**From:** [Jackie McDowell](#)  
**To:** [Hughes, James D.](#); "[Nicole Friedt](#)"; "[David Lorenzo](#)"; "[Brad Catanach](#)"  
**Cc:** "[Timothy Trujillo](#)"; "[Jared Romero](#)"; "[Vesna Delic](#)"; "[Delano Romero](#)"; [rmont27143@aol.com](mailto:rmont27143@aol.com); "[Yolanda Montoya](#)"  
**Subject:** RE: PWDN2019-0037 9331 Corona Ave NE  
**Date:** Wednesday, June 12, 2019 1:13:15 PM

PWDN 2019-0037 – 9331 Corona Ave NE; C-20 Unit 3, TR 3, BLK 16, Lot 23  
Owner: Delano Romero and Vesna Delic  
Engineer: McDowell Engineering, Inc.

Permit: PWDN2019-0037

ROMERO, DELANO - GRADING & DRAINAGE PLAN

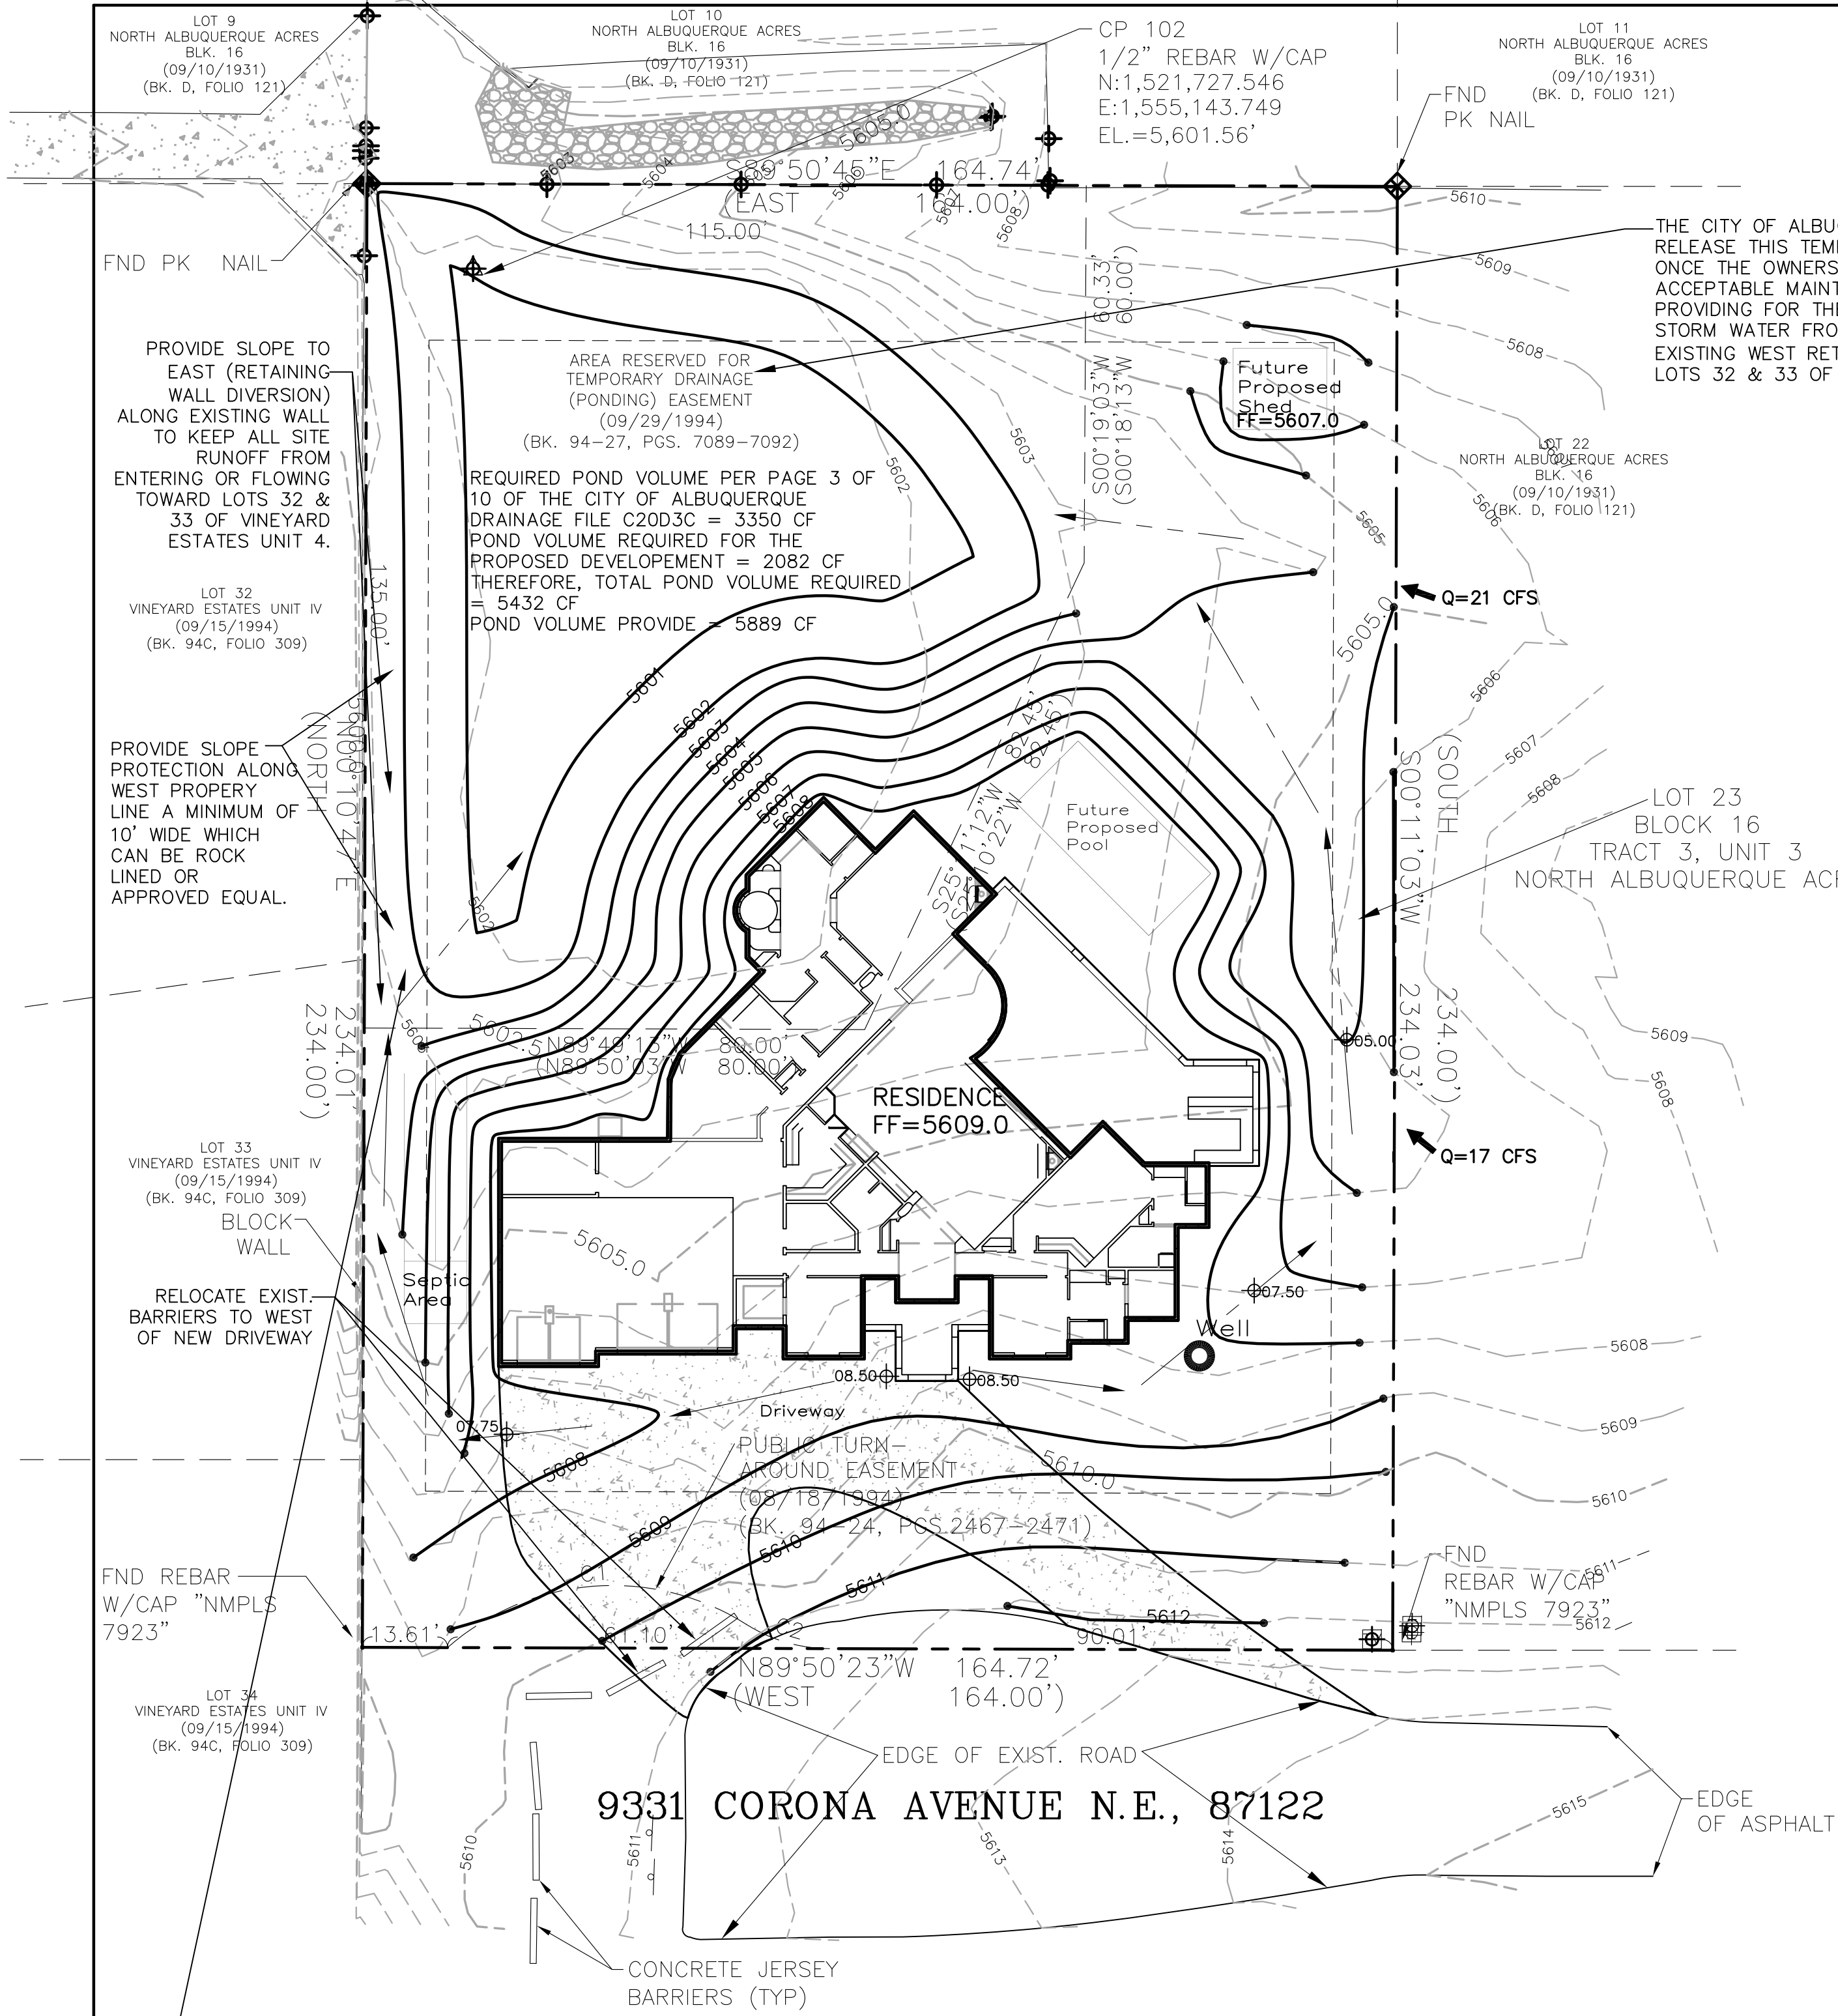
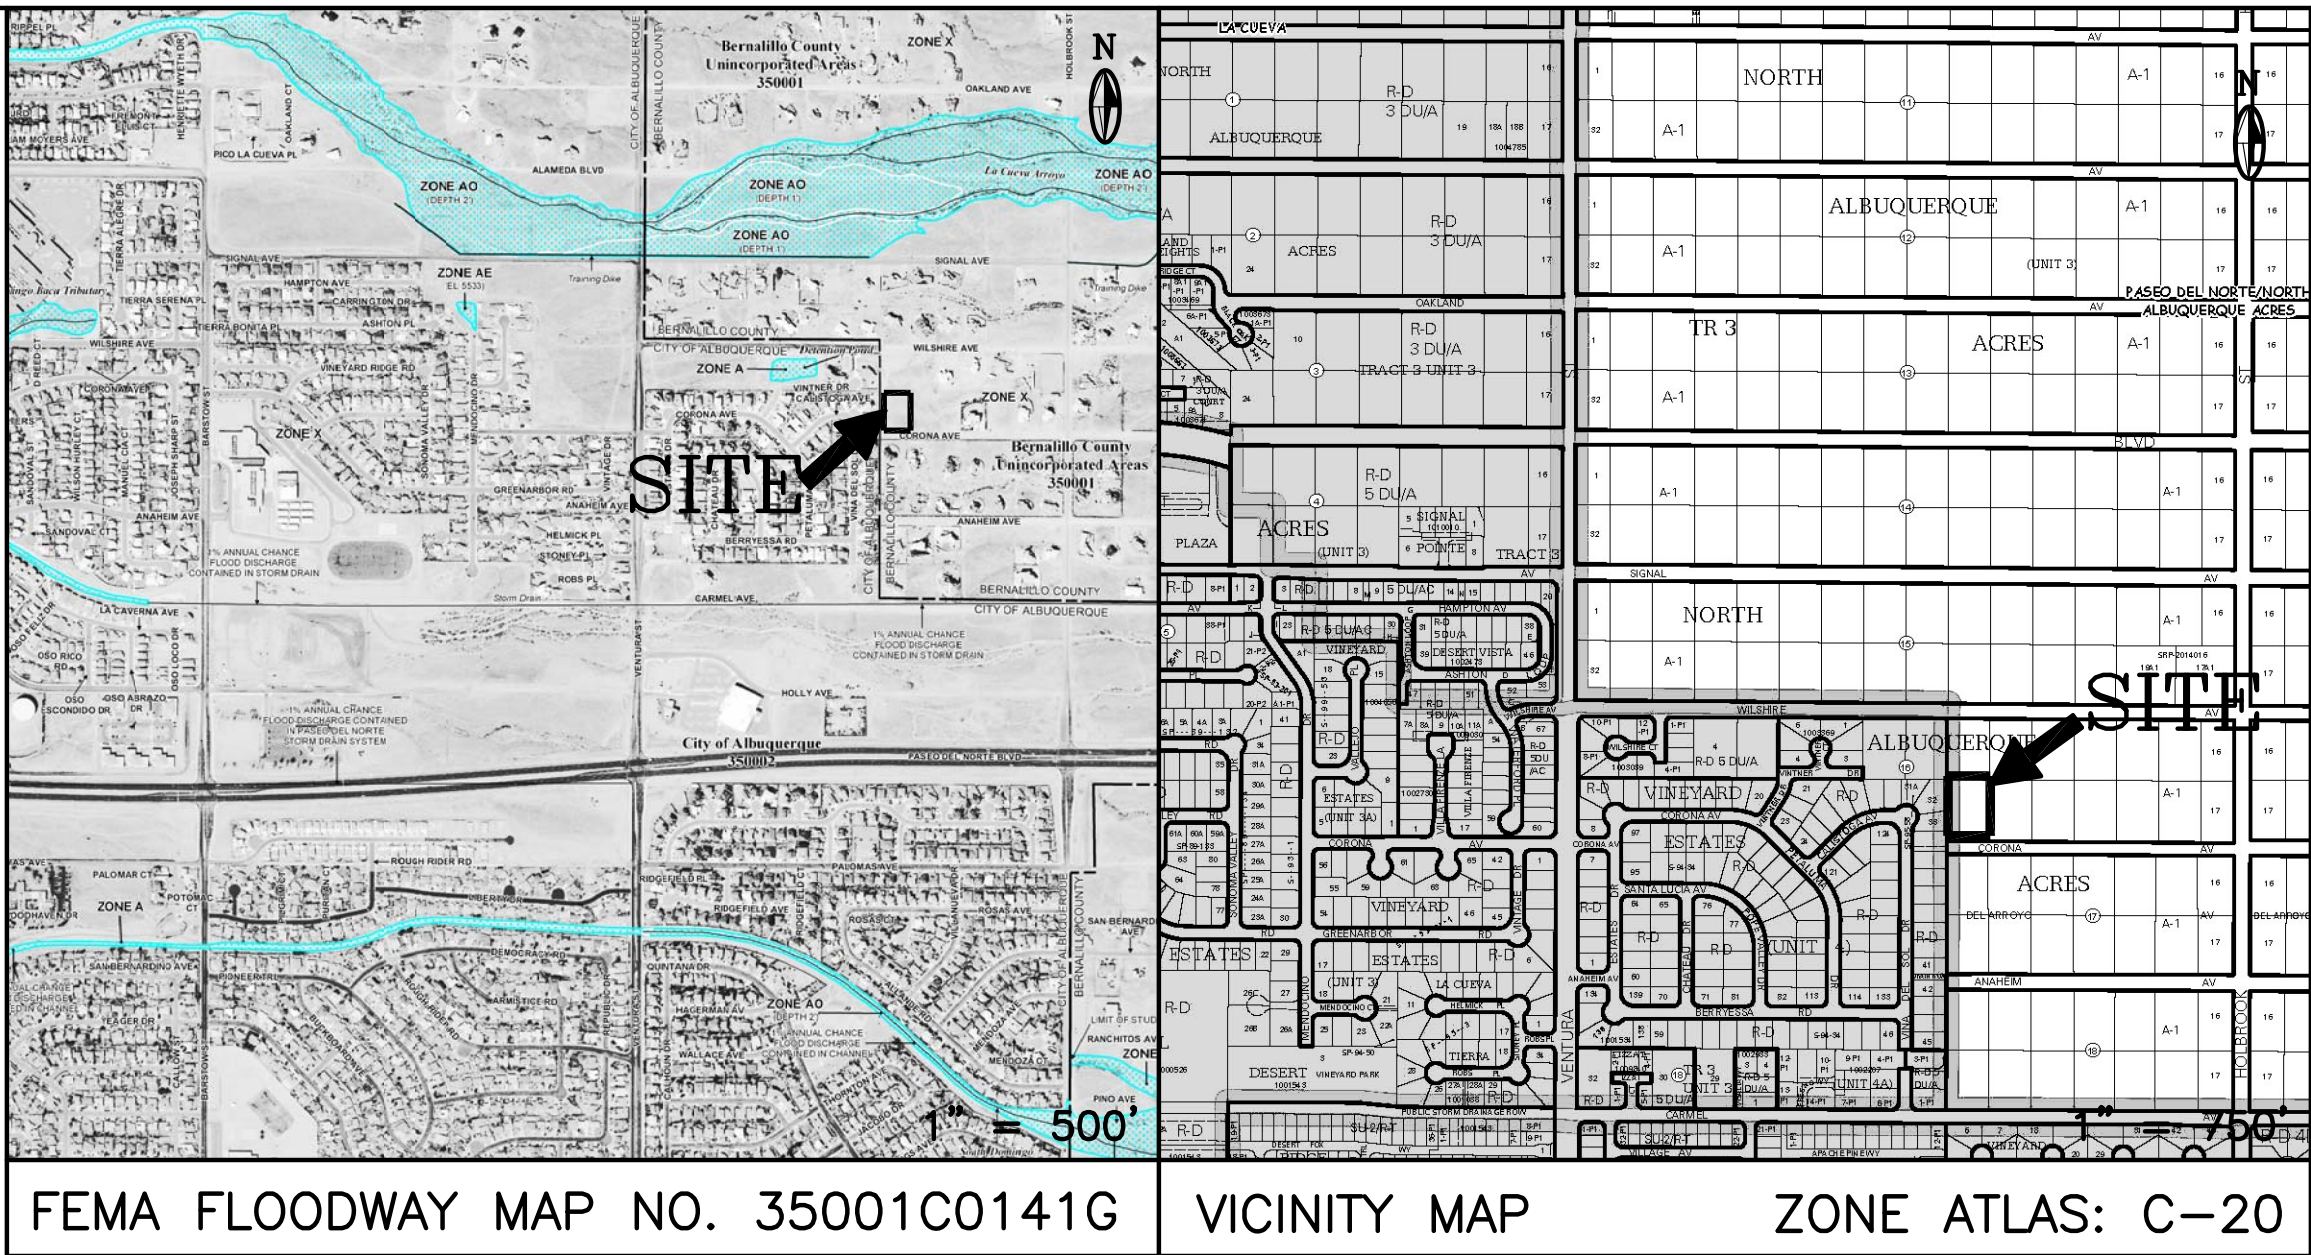
I would like to insure that drainage from this lot should not go into lots 32 and 33 Vineyard Estates Unit 4 by requiring some kind of maintenance covenant for the swales on the north and west sides of 9331 Corona Ave.

I support releasing the existing City easement and defer to the County and AMAFCA on whether or not the pond is needed. I would like to see a recorded Maintenance Covenant and/or Easement to insure the continued maintenance of the retaining wall (diversion) on the west side of 9331 Corona Ave. before I release the existing easement. Note that the footing for the existing wall probably encroaches into this lot. It could be a private easement granted to the owners of lots 32 and 33 for the purpose of maintaining the existing diversion/ floodwall with the owner of 9331 Corona responsible for the maintenance, or use standard language from one of the three public entities.

1. The house is sited within the City Easement.
2. Please provide verification that the attached City Easement has been vacated.
3. If not vacated, will the Easement limits be modified to not include the house?
4. Provide a copy of the excerpt of the City Drainage file referenced for required pond volume.
5. Who has maintenance responsibility of the pond? How will it be accessed for maintenance?
6. How will the pond spill and what measures will be used to stabilize it?

Attached is the revised Grading & Drainage plan which incorporates comments along with the standard County Drainage Covenant incorporating maintenance concerns by the City for protection of storm water flow for the properties to the west (Lots 32 & 33, Vineyard Estates Unit 4). Please review and let me know if you require any adjustments before we make the formal resubmittals. We have received the County approval (attached) for the previous submittal and trust that AMAFCA's comments are addressed by the communications with the City of Albuquerque.

As shown by the plan, the structure is located in the southerly/center portion of the lot. On site flows will drain around the structure via swales and sheet flow, and flow to the south to existing drainage paths. The calculated flow is more than that that allowed, therefore, retention ponding is necessary and shown on the plan. The ponding has been designed to provide the volume for the proposed development plus the required pond volume per the City of Albuquerque drainage report for the subdivision west of the site.
